ALERT SERVICE BULLETIN

NO. 204-01-53

MODEL AFFECTED: 204B

SUBJECT: MAGNETIC BRAKE P/N 204-001-376-003, ONE TIME INSPECTION OF.

FIGURE 1

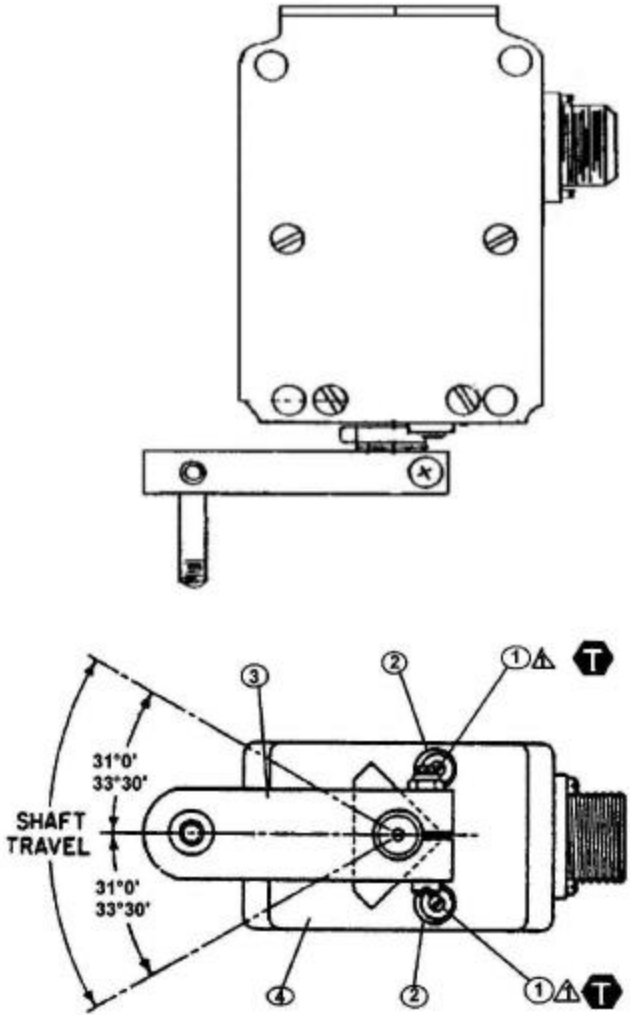
6. Using a suitable torque wrench and screw driver bit apply 10 inch/lbs. (1.12 Nm) force to screw(s) (1, figure 1) in a counterclockwise direction. If screw(s) (1) does not move, proceed to step 12. If any movement is found on screw(s) (1) proceed to the following steps.

If the inspection reveals that screw(s) (1) has disengaged, inspect arm assembly (4) for mechanical damage created by screw (1). If mechanical damage is found, the depth shall not exceed 0.030 inch (0.762 mm). Acceptable damage may be smoothed and treated in accordance with the Standard Practice Manual Chapter 3 for Chemical Film. If damage is greater than 0.030 inch (0.762 mm) contact Product Support Engineering.

7. Remove screw(s) (1) and stop limit(s) (2) from magnetic brake (4).
8. Clean residue adhesive from magnetic brake (4) screw holes and screw(s) (1) with compressed air.

9. Apply adhesive (C-320) to screw(s) (1) threads and install in magnetic brake (4) hand tight.
10. Adjust the stop limit(s) (3) to achieve the arm assembly shaft travel as per dimensions in BHT-204B-MM Maintenance Manual, Chapter 7.
11. Once shaft travel is obtained, torque screws (1) 5 to 10 in-lbs (0.56 to 1.12 Nm).
12. Apply torque seal inspection ink to screws (1) and to stop limits (2).
13. Re-install cyclic fore & aft and lateral magnetic brakes into aircraft.
14. Re-install cyclic and anti-torque magnetic brake access panels.
15. Connect battery.
16. Make an entry in the helicopter historical records indicating compliance with this Alert Service Bulletin.

-  Bond screw with adhesive C-320
-  5 to 10 IN-LBS
(0.56 TO 1.12 Nm)
